CO 199 Bikeway

Concept Design Validation Memo

Appendix A Concept Plan Mark-Up

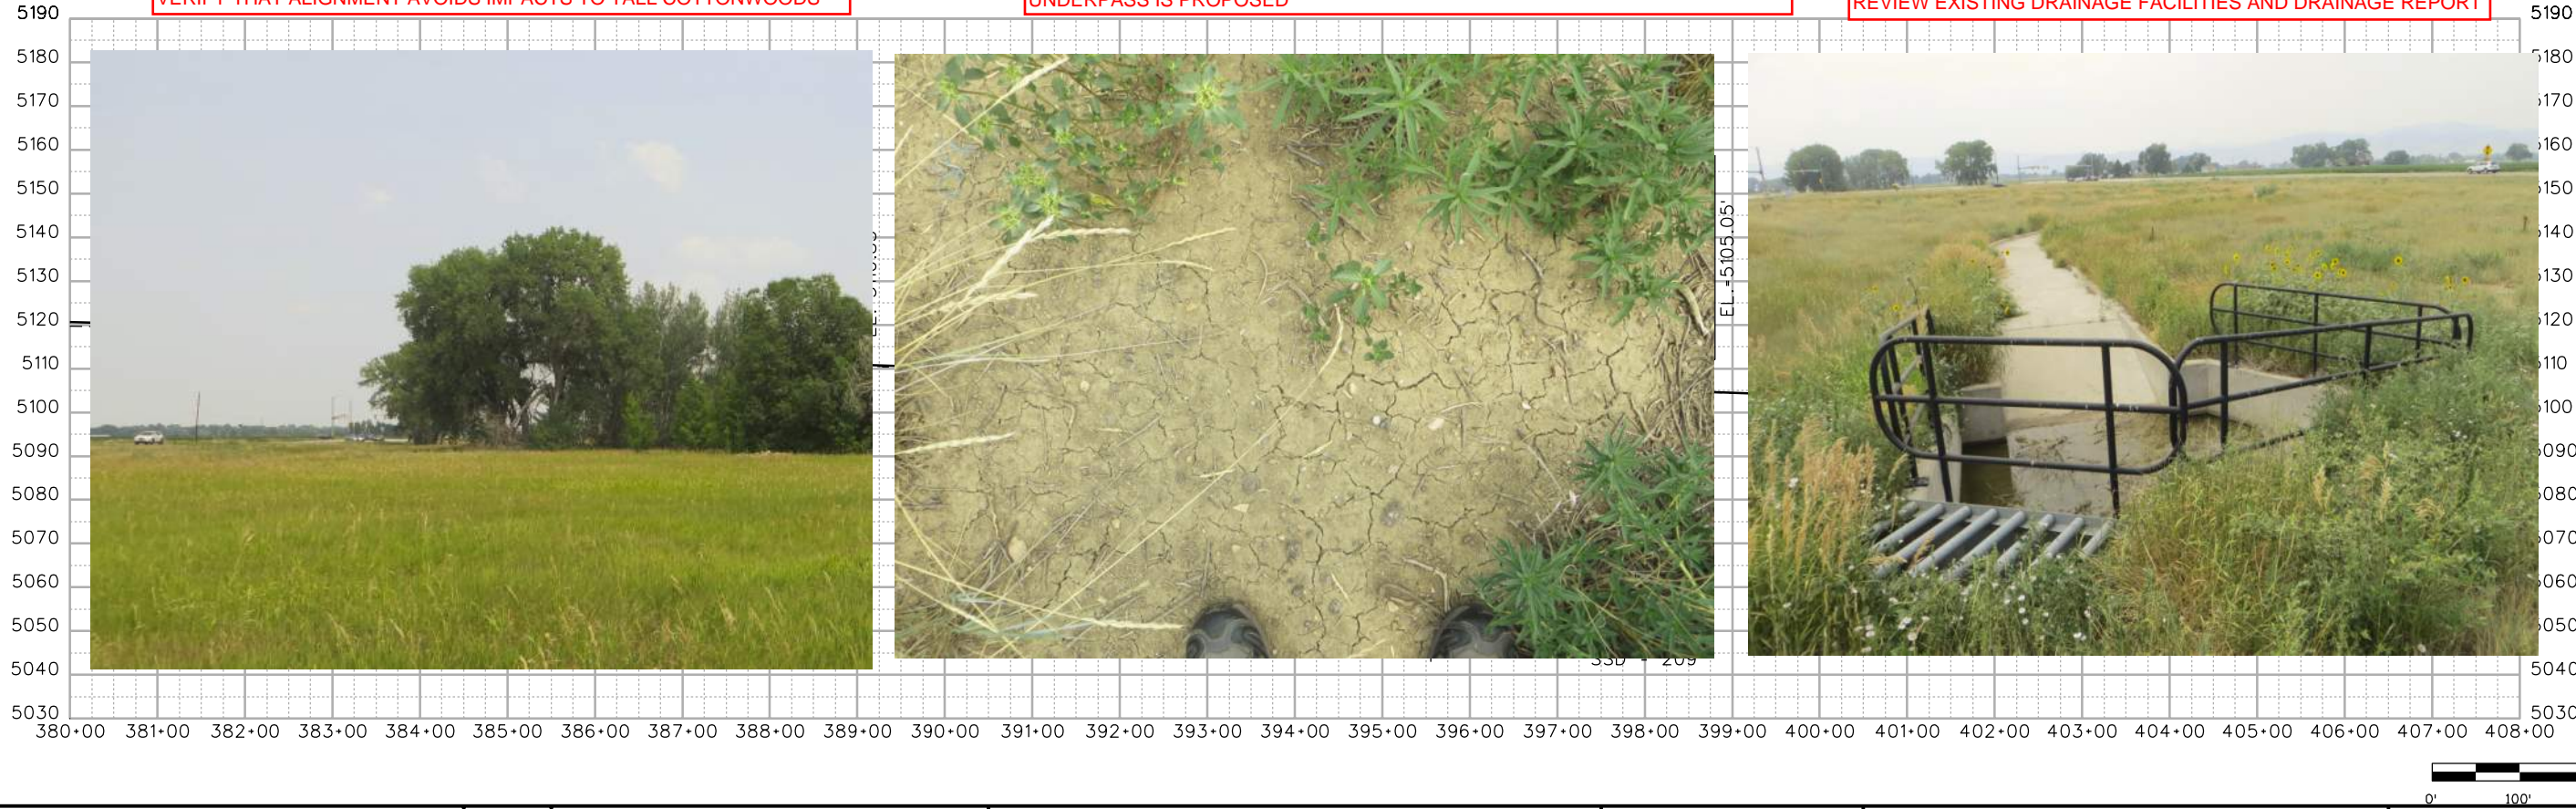
REVIEW EXISTING DRAINAGE FACILITIES AND DRAINAGE REPORT

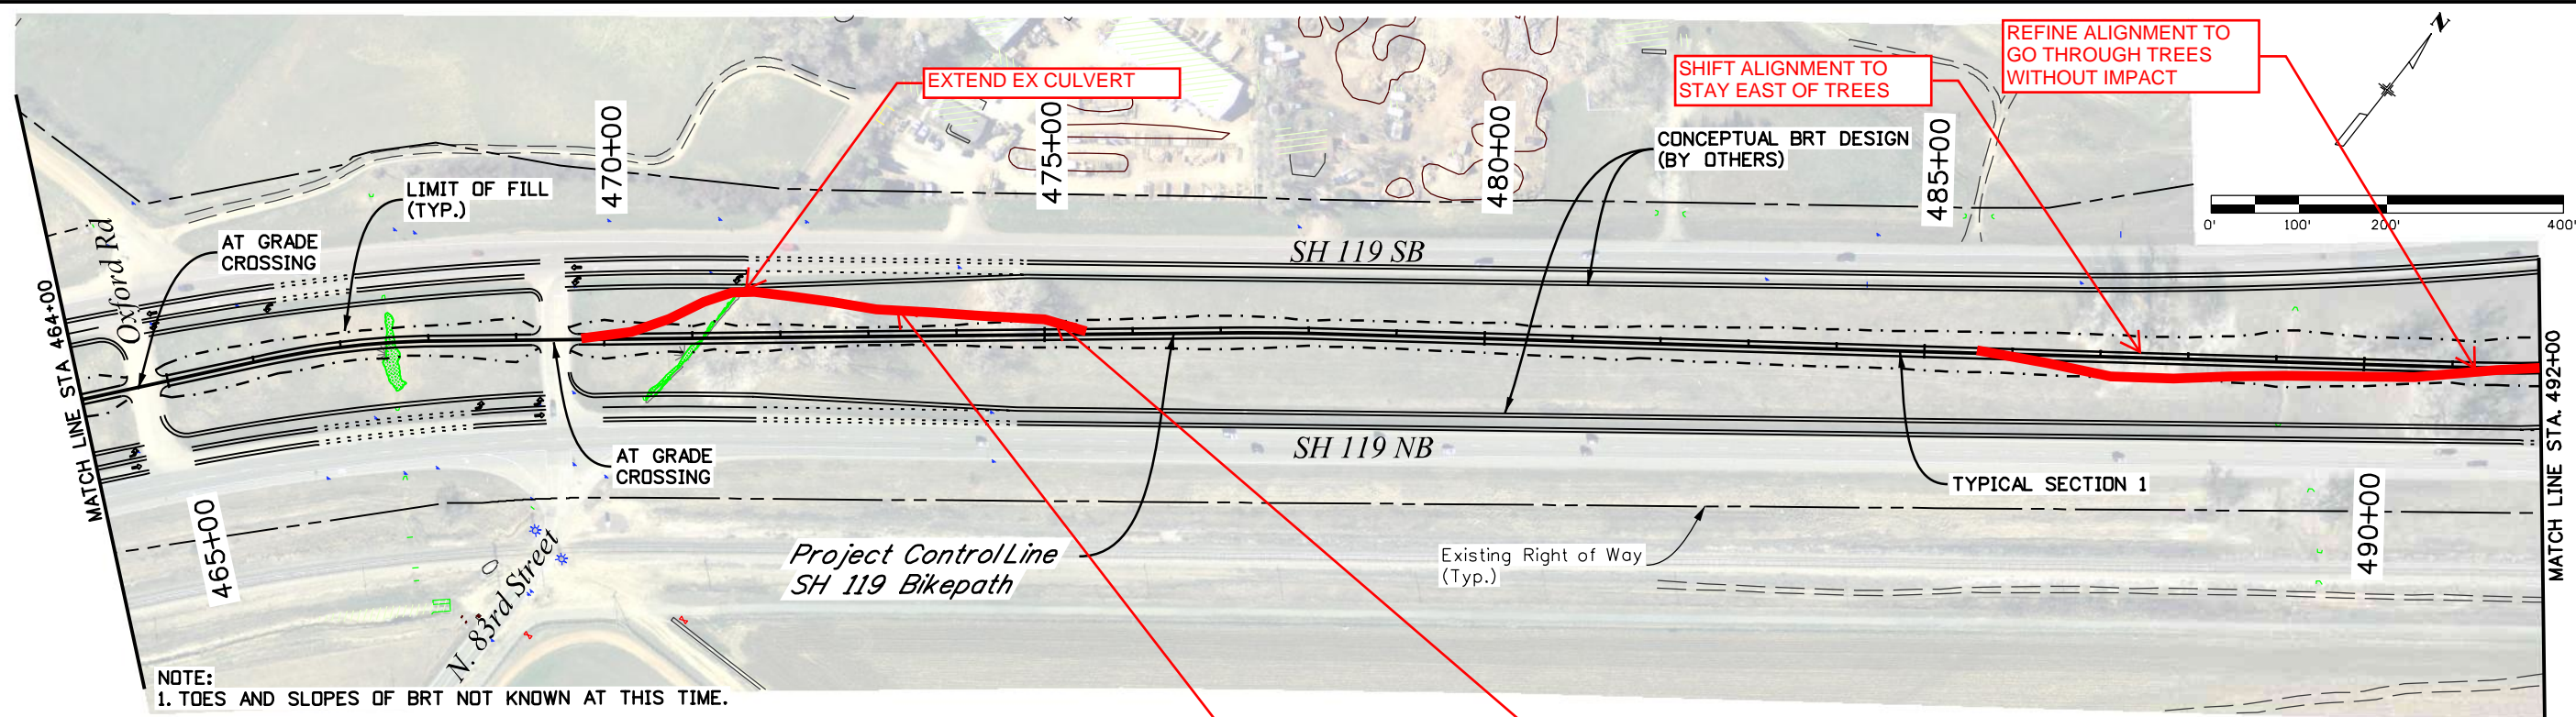
SHIFT ALIGNMENT TO STAY WEST OF TREES

REFINE ALIGNMENT TO GO THROUGH TREES WITHOUT IMPACT

PLAN AND PROFILE			
Designer:	KRC	Structure	
Detailer:	REW	Numbers	
Sheet Subset:	P&P	Subset Sheets:	15 of 18

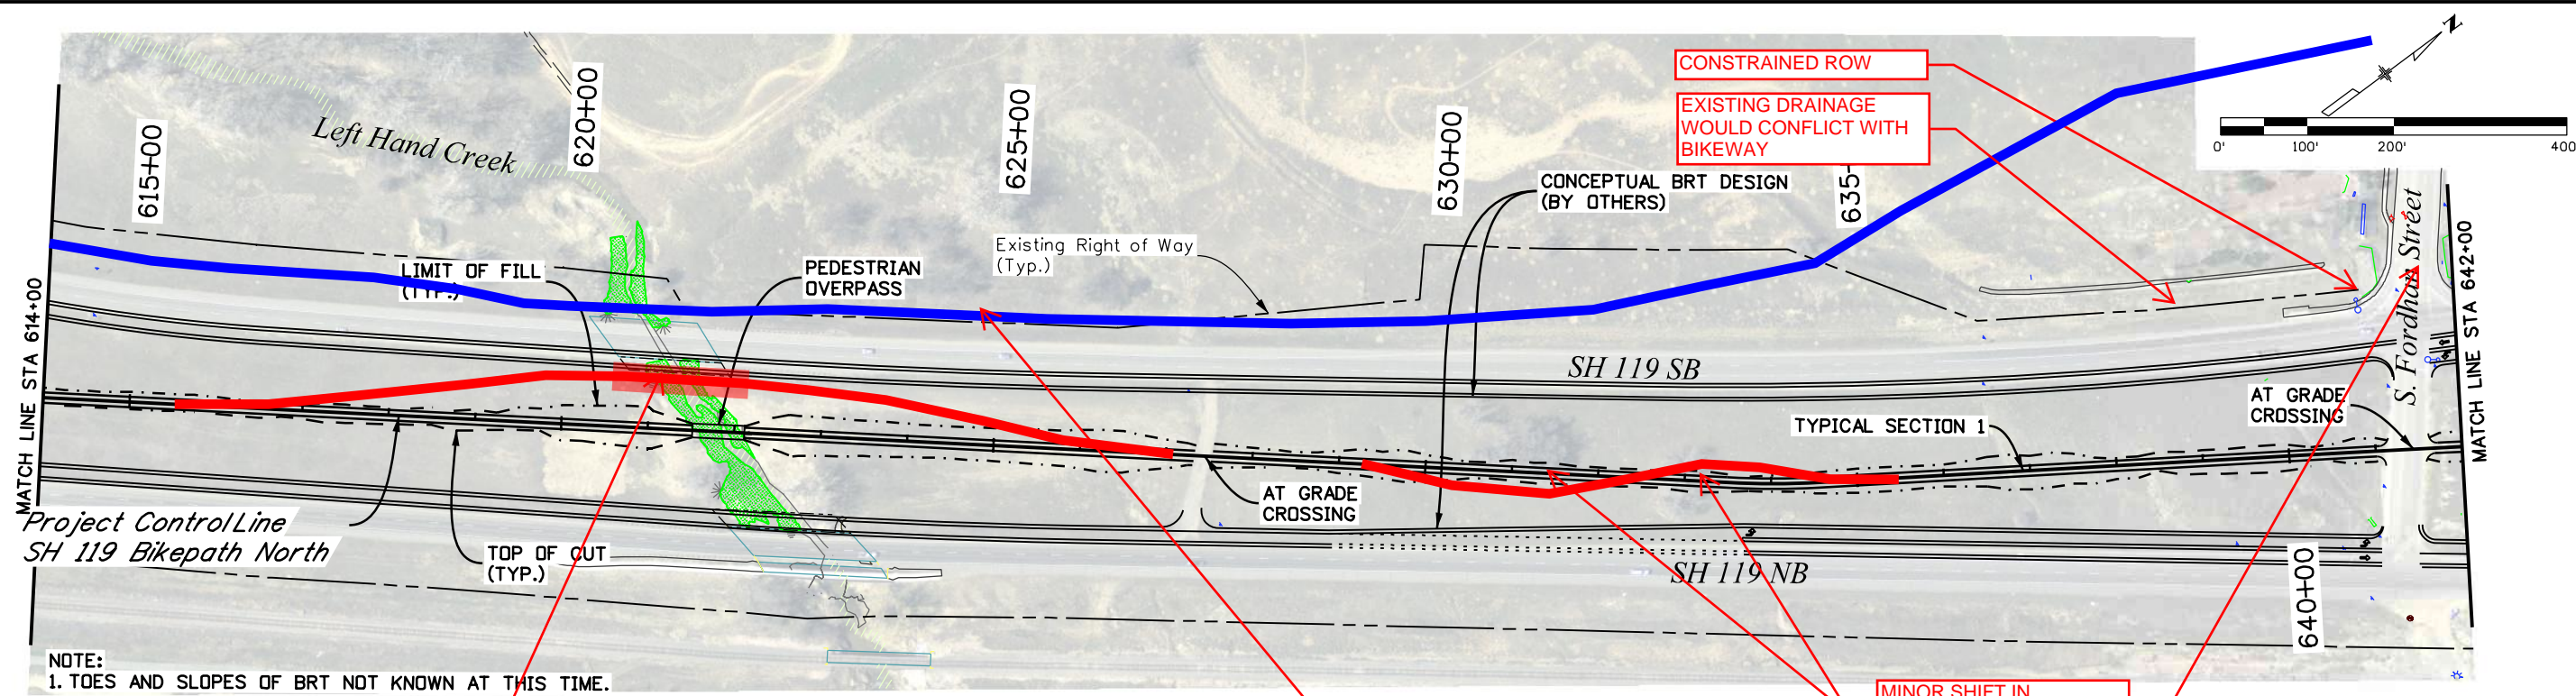
MINOR SHIFT IN ALIGNMENT TO AVOID TREES

Left Hand Creek
INCLUDE BIKEWAY IN BRIDGE WIDENING NEEDED FOR MP OR LOCATE SEPARATE BIKEWAY BRIDGE ADJACENT TO 119 TO MINIMIZE WETLANDS, TREE AND FLOODPLAIN IMPACTS

EMERGENCY CROSSING
POTENTIAL ROW ENCROACHMENT, ROW LOCATION MUST BE VERIFIED

S. Fordham Street
SIGNIFICANT DRAINAGE CROSSING AND OTHER OBSTRUCTIONS PREVENTS AT-GRADE CROSSING OF FORDHAM NEAR 119
